5. Modifications to the Project

5.1 Design changes

5.1.1 Schofields pedestrian footbridge

Figure 5-1 Amended location of the Schofields pedestrian footbridge

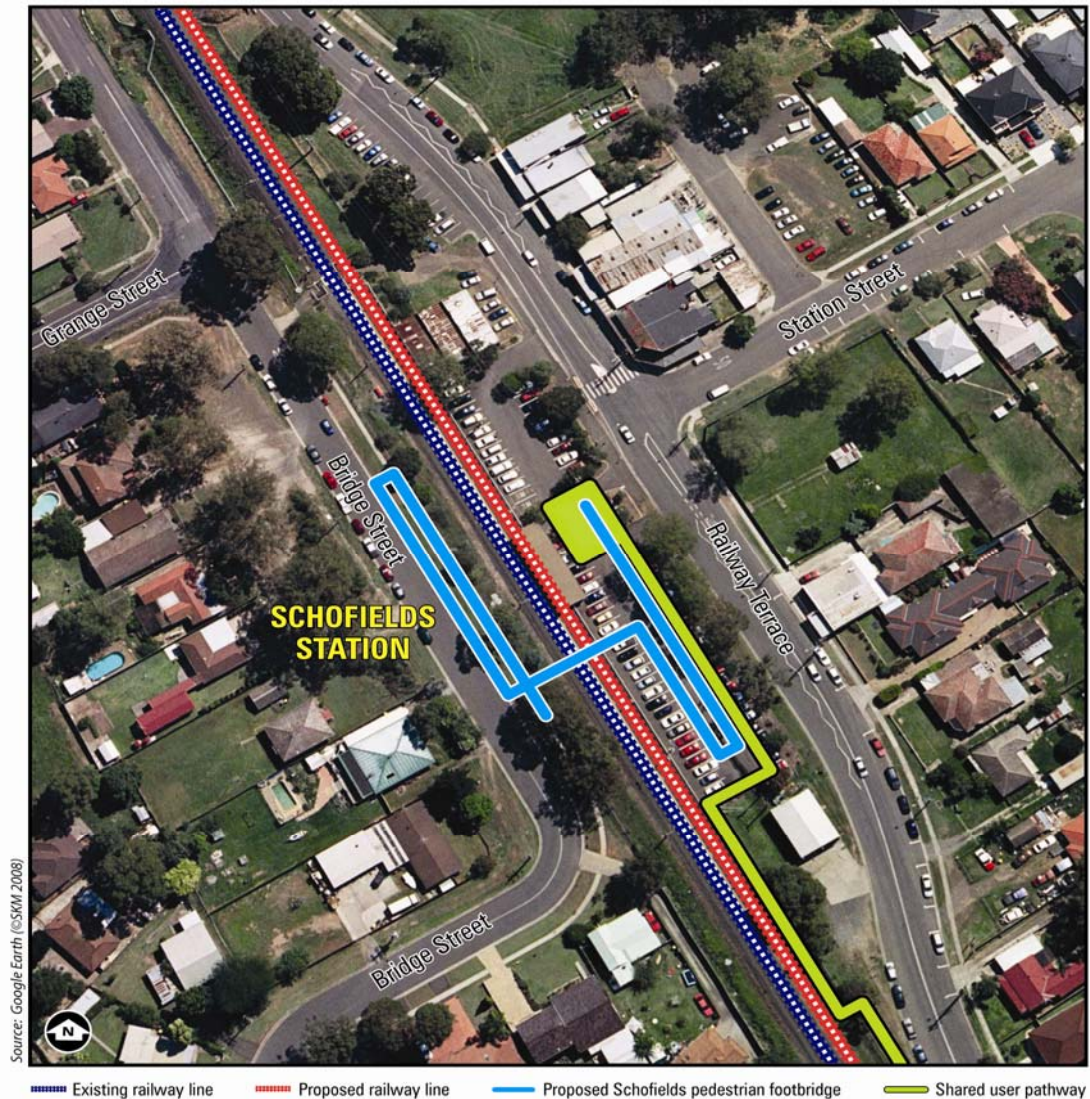
The proposed location of the Schofields pedestrian footbridge, as described in Section 6.2.2 of the Environmental Assessment, has been amended to take advantage of an opportunity to reduce the total walking distance between the eastern and western sides of the rail corridor. The new location of the pedestrian footbridge is proposed to be at the site of the existing Schofields Station (refer Figure 5-1). While the overall height of the footbridge would remain the same (i.e. 8 metres from ground level to the footbridge floor), relocating the footbridge to this location would reduce the total walking distance by approximately 100 metres (refer Table 5-1) for footbridge users. This reduction would arise from shortening the up and down ramps due to the topography of the ground in this area with no resultant change to the height above the track.

Figure 5-2 Indicative landscaping plan for Schofields pedestrian footbridge

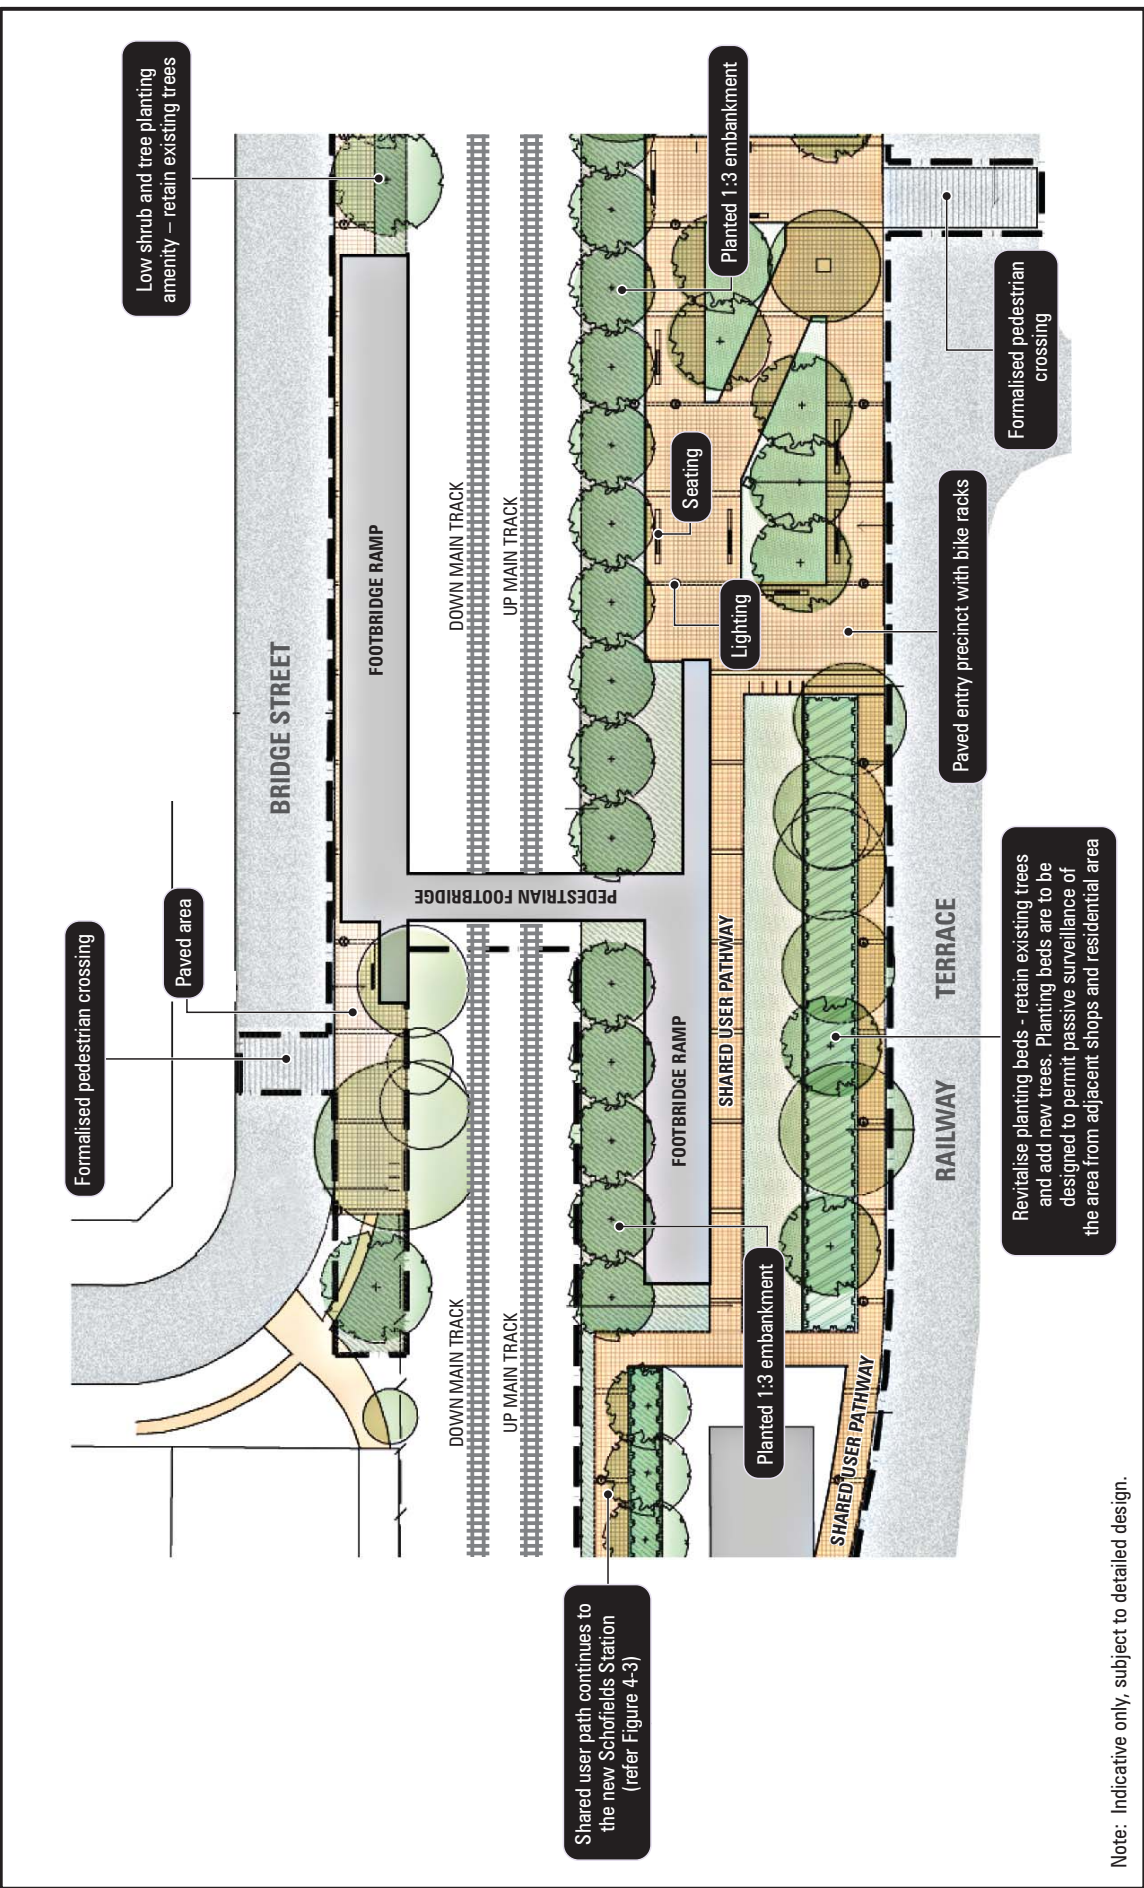
An indicative landscape plan for the Schofields pedestrian footbridge and decommissioned station site is provided in Figure 5-2. While this indicative plan is still in a preliminary planning phase, it is expected to incorporate the following:

- Footbridge design and tree plantings would consider the site aspect, shadowing and the pattern of sun movement to minimise the overshadowing of adjacent land uses.

- The use of reflective finishes would be avoided, where possible.
- Soft landscaping with indigenous species would be adopted to screen/soften the visual impacts associated with built structures and to rehabilitate the vacant station site. Plantings would be located so as to permit passive surveillance of the area from the adjacent shops and residential area and to not preclude pedestrian movements between the footbridge and the shared user path along Railway Terrace.

Figure 5-3a Proposed modifications to the utility corridor and Biodiversity/Indigenous heritage constraints

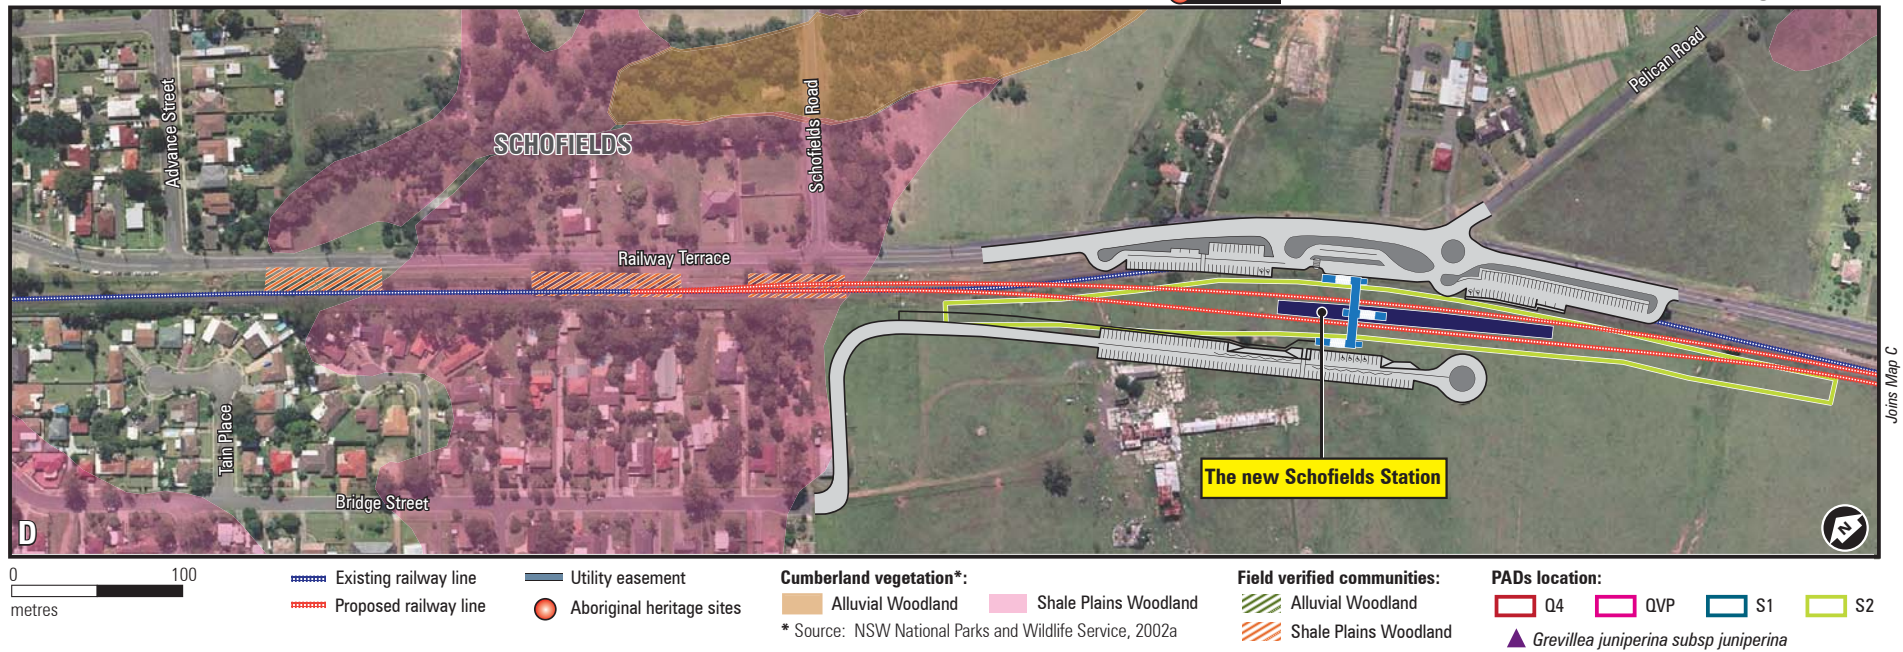
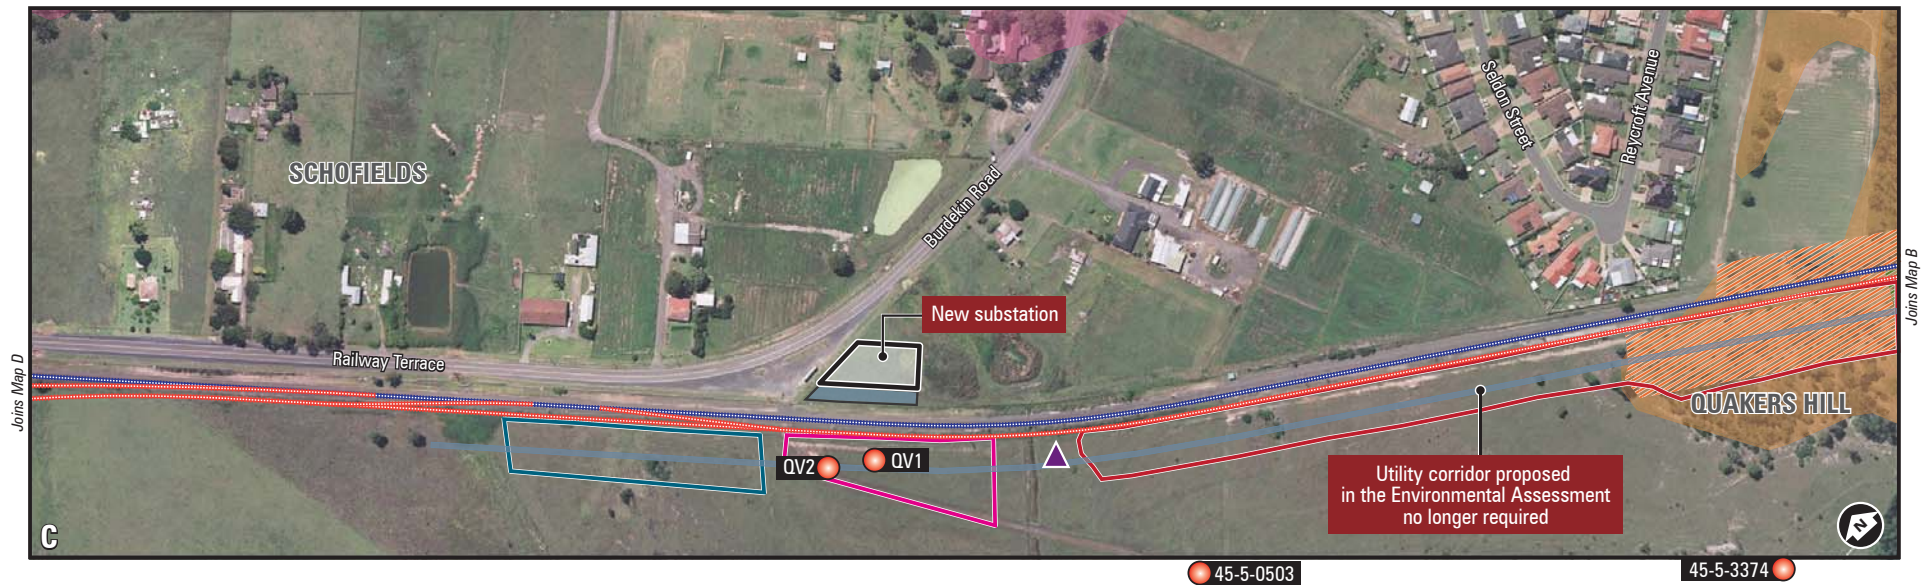
- Sydney Water Corporation (Sydney Water) advised that it requires a 5 metre utility corridor for its assets instead of a 3 metre corridor as proposed in the Environmental Assessment (on the eastern side of the corridor directly north of Quakers Hill Parkway, Quakers Hill). This would result in the widening of the easement on the eastern side of the rail corridor by 2 metres over an approximate length of 370 metres, totalling an additional 740 m² of land, much of which is vegetated (refer Figure 5-3).

- Nirimba Educational Precinct (TAFE NSW) and TIDC/Richmond Line Alliance assessed the original proposal to relocate the sewer main north along the western side of the rail corridor and concluded that a more optimal and maintainable solution involved relocating the sewer south to connect into the Sydney Water main located adjacent to Quakers Hill Parkway, off Nirimba Drive. This would result in a reduction in the length of the originally proposed easement by approximately 1,200 metres with a corresponding reduction in area of 3,600 m². Of the 1,200 metre reduction in easement, approximately 700 metres is vegetated (2,100 m²), which would no longer be required to be cleared. The connection point for the sewer main would also require the installation of a simple sewer vent structure.

The abovementioned modifications to the proposed utility corridor are shown in Figure 5-3. An assessment of the impacts likely to be associated with the proposed modification to the utility corridor is provided in the following sections. A summary of these impacts, relative to the impacts documented in the Environmental Assessment, is provided in Table 5-3.

Widening the 3 metre wide utility corridor on the eastern side of the rail corridor would result in an impact to an additional 2 metre strip of one PAD area, identified as Q3 in the Environmental Assessment (refer to Figure 5-3). It should be noted, however, that the proposed widening of the utility corridor would not impact on the full extent of this PAD area.

Shortening the length of the 3 metre wide utility corridor on the western side of the rail corridor from 1,800 metres to 600 metres would avoid the impact to a 3 metre strip of four PAD areas, identified as Q2, Q4, QVP and S1 in the Environmental Assessment (refer to Figure 5-3). These PAD areas would still be partially impacted, however, due to the widening of the rail corridor to accommodate the duplicated track.

Figure 5-4 Proposed construction compounds for the Project

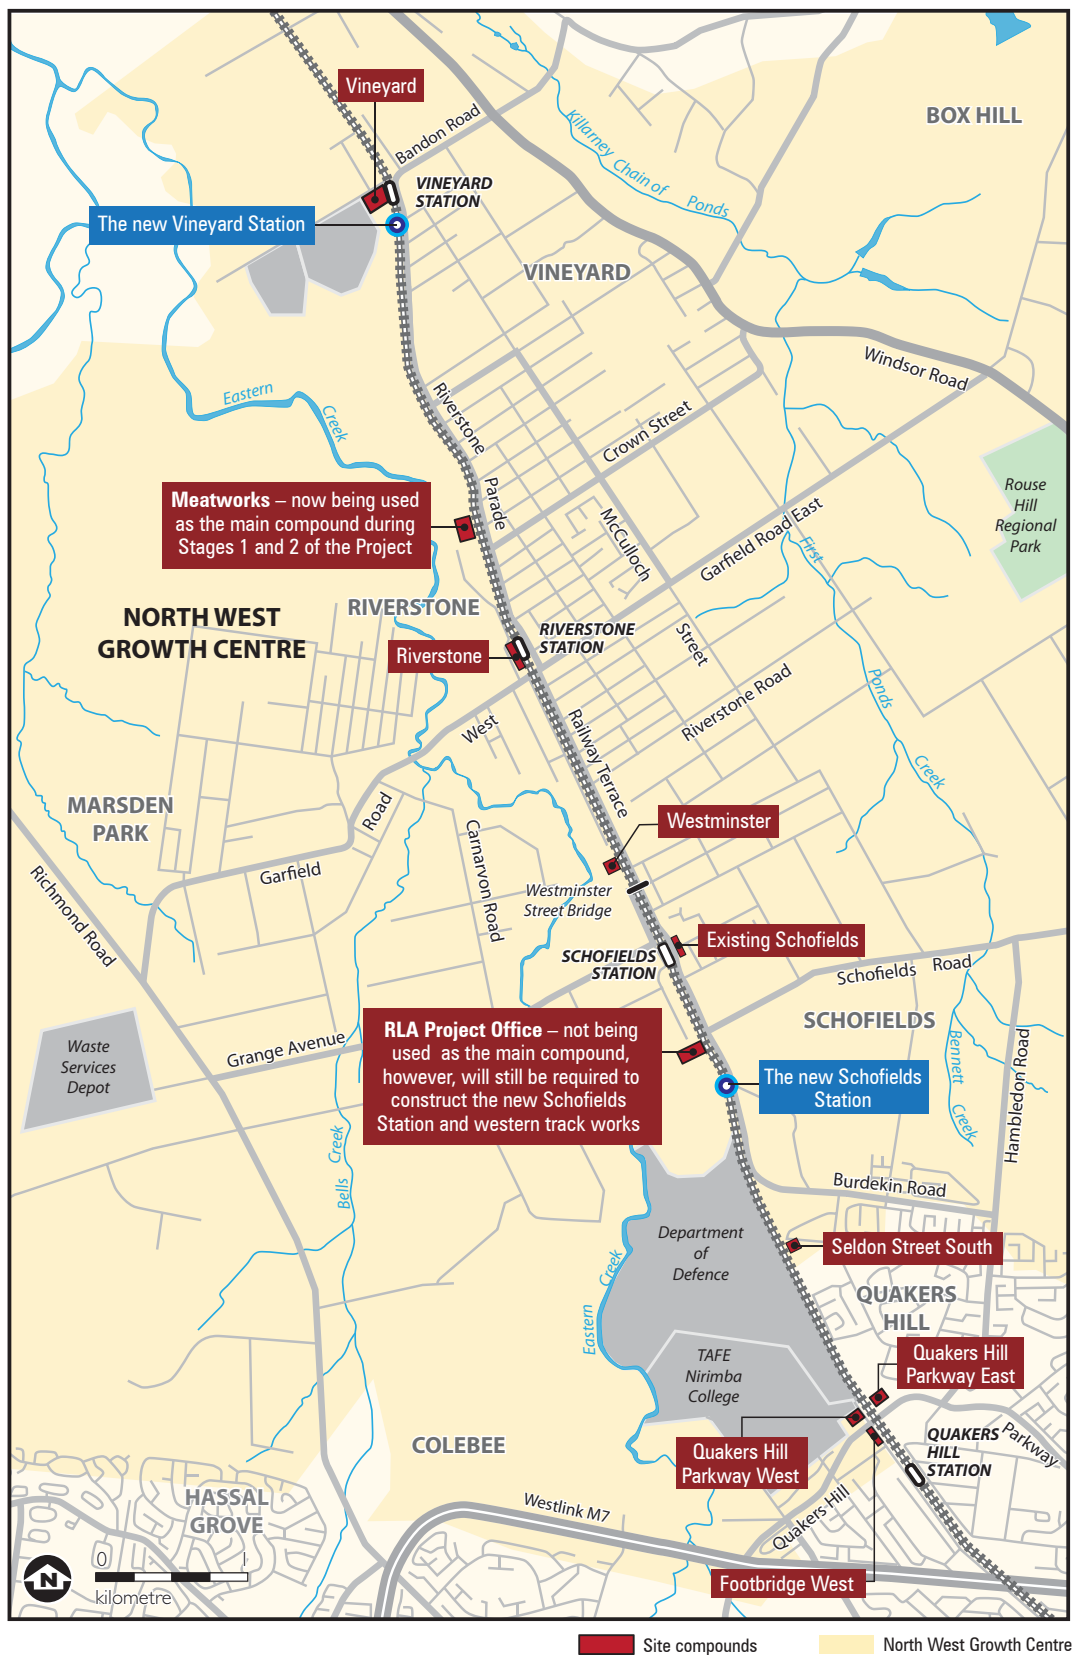
The location of the main construction compound for the Project, as described in Chapter 10 of the Environmental Assessment (i.e. the location of the new Schofields Station) has been amended to be located at the Meatworks. As such, the Meatworks site compound would become the main compound during both Stages of the Project. Section 10.3.10 of the Environmental Assessment originally proposed that the Meatworks compound would be used in Stage 2 only. The Meatworks would cater for approximately 60 staff plus direct and sub-contractor workforce, totalling 200 workers during the peak construction works. As the Meatworks site was proposed as the main Project site compound/office for Stage 2 in the Environmental Assessment, there would be no increase in its proposed size/scale, rather its use would be initiated earlier (for both Stage 1 and 2 instead of just Stage 2).

As per Chapter 10 of the Environmental Assessment, another smaller compound is proposed to be established at Quakers Hill during the construction of Stage 1 of the Project (identified in Section 10.3.1 of the Environmental Assessment as Compound 1 – Footbridge East). This compound was to be used to service the eastern rail construction works and would cater for up to 20 people. The compound would not be required to construct the Quakers Hill footbridge as this facility is no longer proposed as part of this Project (refer Section 5.1.3).

The proposed locations for the site compounds, including stockpile sites and laydown areas, are shown in Figure 5-4.
